BY: Rolando Ionta	DATE: 29-Mar-00
	CHK'D:	DATE:
	Project No. YY-XXX	
	Description: Client Name Here	
	Crane Drive Inspection & Repair Recommendations	
Report e-mailed to "Mr. XXXX" on mm/dd/yr.		
Tape No. 2 3/01/00; 10:06 AM		
<u>Purpose of Inspection:</u>		
<p>"Mr. XXXX" of "Client Name" requested that CMM inspect the South Bridge Drive of the No. "XXX" Teeming Crane. "Mr. XXXX" advised that the south drive was observed by staff to have excessive movement when the crane was accelerated and especially during deceleration by plugging the crane. The purpose of the project was to visually observe the crane during typical acceleration and deceleration followed by a detailed visual inspection of the south drive. Repair recommendations were to be provided for any deficiencies found.</p>		
<u>Data Provided by Client:</u>		
<p>The following data/information was provided by "Mr. XXXX" during the field inspection of March 1, 2000.</p> <ol style="list-style-type: none"> 1- 8 1/2 X 11 size copies of drawings XXXX-1, XXXX-2 and XXXX-3. 2- Opportunity to ride the crane and visually observe both the north and south bridge drives during accelerating and decelerating in a NO LOAD condition. 3- A ma

PHOTO No. 1

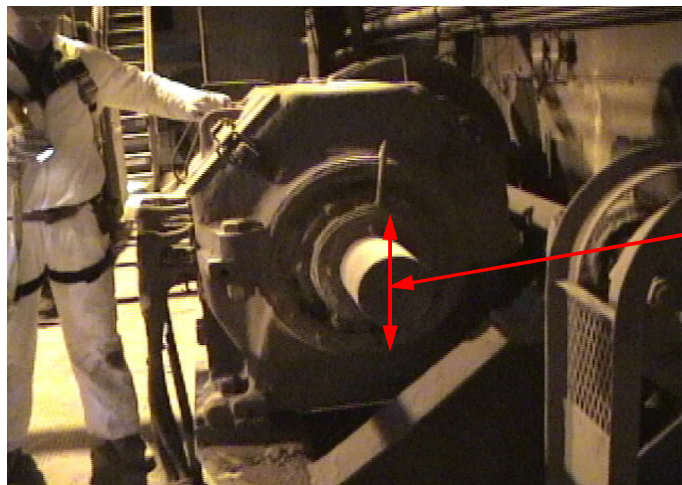
General Photo looking west at the south bridge drive during NO LOAD test operation.

The whole drive assembly was observed to have significant vertical movement during acceleration and deceleration.

PHOTO No. 3

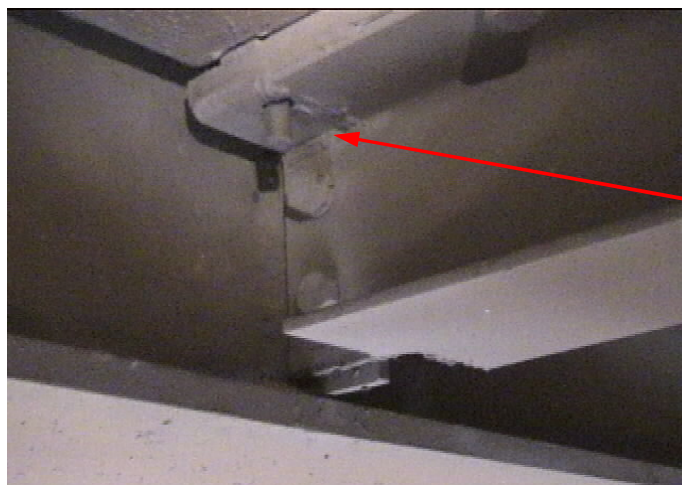
This is a view looking at the north end of the east beam. Notice the following.

- 1- Nut missing on bolt.
- 2- Previous repair weld has cracked.
- 3- Crack in weld has propagated into beam web base metal.

See close up view in photos 4 & 5 below.

- 1- Repair the crack on the north end of the east beam as shown in photos 3, 4 and 5.
- 2- Repair the crack in the northwest corner of the motor mounting base plate as shown on the marked-up print and section X-X by adding:
 - a- Stiffener bar- ITEM NO. 1
 - b- Reinforcing angle- ITEM NO. 2
 - c- Beam Stiffener- ITEM NO. 4
- 3- Stiffen entire west side by adding stiffener bar- ITEM NO. 1
- 4- Repair crack in motor mounting plate shown in photos 6 and 7 in accordance with instructions on marked-up print.
- 5- Repair top flange of support beam shown in photos 6 and 7 by adding a reinforcing angle as shown on marked-up print section Y-Y; ITEM NO. 3.
- 6- Install 3 beam stiffeners on east beam- ITEM NO. 4
- 7- Replace all drive mount bolts with new grade 5 or A325 bolts.

**PHOTO No. 6**

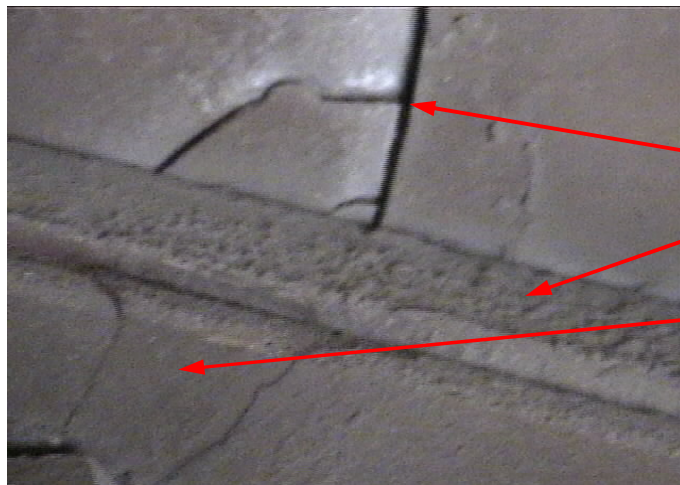
View looking at extreme south connection on the east drive support beam.

Motor mount base plate is severely cracked.

Portion of support beam flange is completely cracked through.

See close-up view in photo 7 below.
